**WOODBERRY DOWN**

**PHASE 4: WDCO PRESENTATION - 2ND ESCAPE STAIRS  
JULY 2023**

# PHASE 4 UPDATE

This document sets out the proposed amendments to the scheme to incorporate the requirements of the new document.

## solar exposure - 21st march

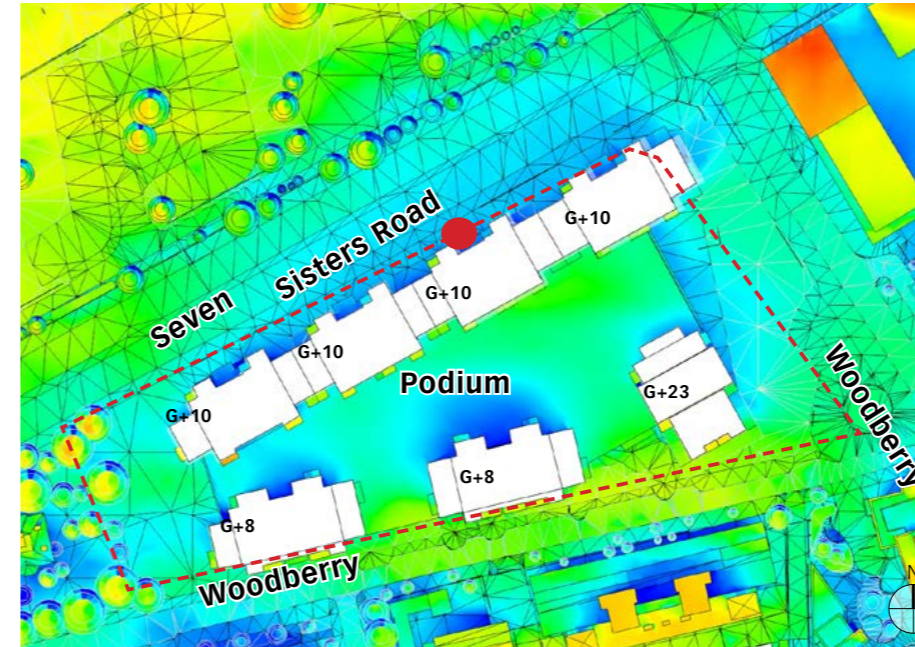
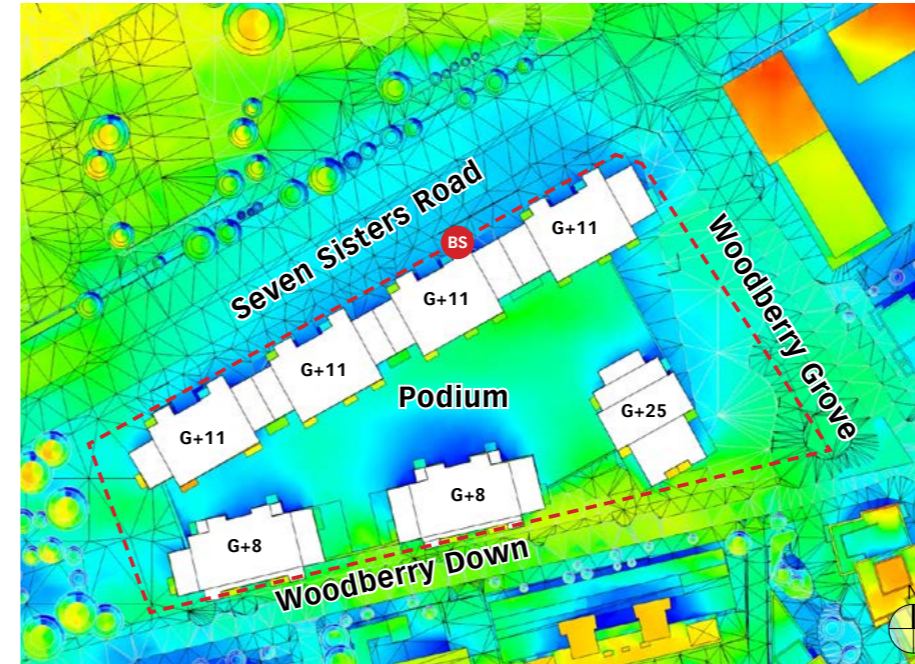
The 2022 Scheme was fully compliant with BRE Guidelines with all outdoor amenity areas receiving at least 2 hrs sunlight on the 21 March to >50% of the area.

The additional height has a negligible impact on sunhours in the public spaces - a change of 0.36% in the new central square.

## daylight effect map - scheme 2022 vs proposed scheme

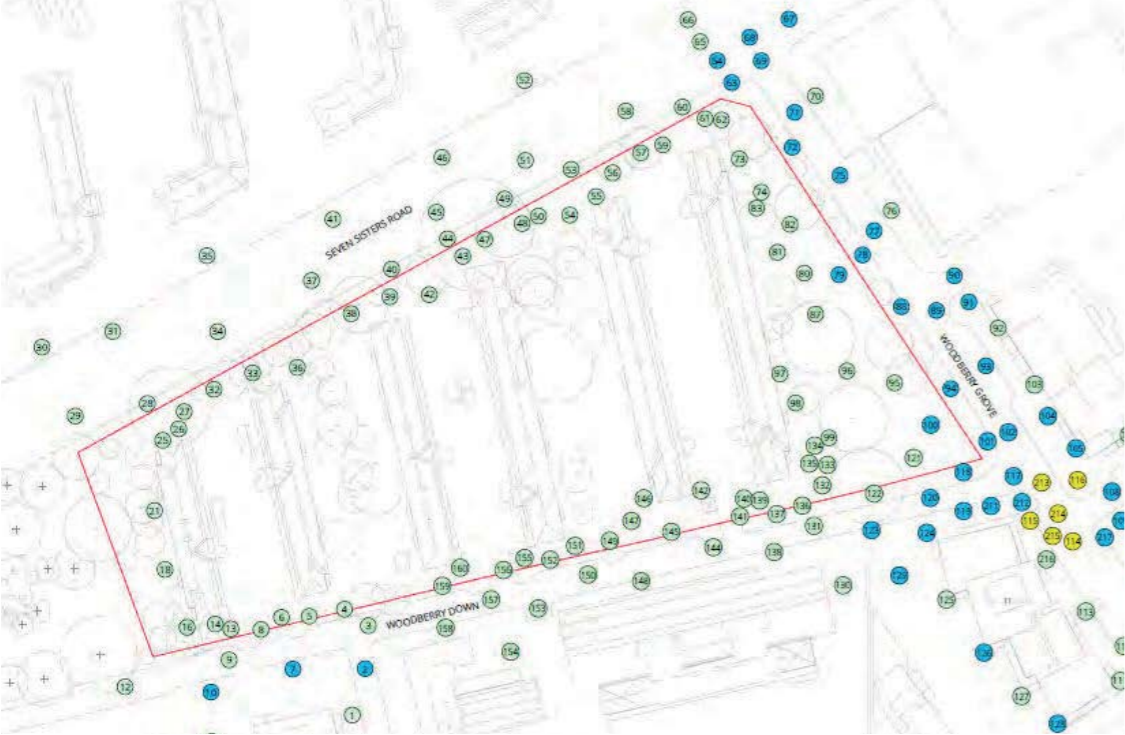
The differences in retained daylight levels between the 2022 Scheme and the 2 Stair Scheme are negligible.

2022 Scheme.  
VSC daylight test  
86% of all windows tested meet the BRE guidelines  
97% of all rooms tested meet the BRE guidelines

2 Stair Scheme.  
VSC daylight test.  
83% of all windows tested meet the BRE guidelines  
97% of all rooms tested meet the BRE guidelines
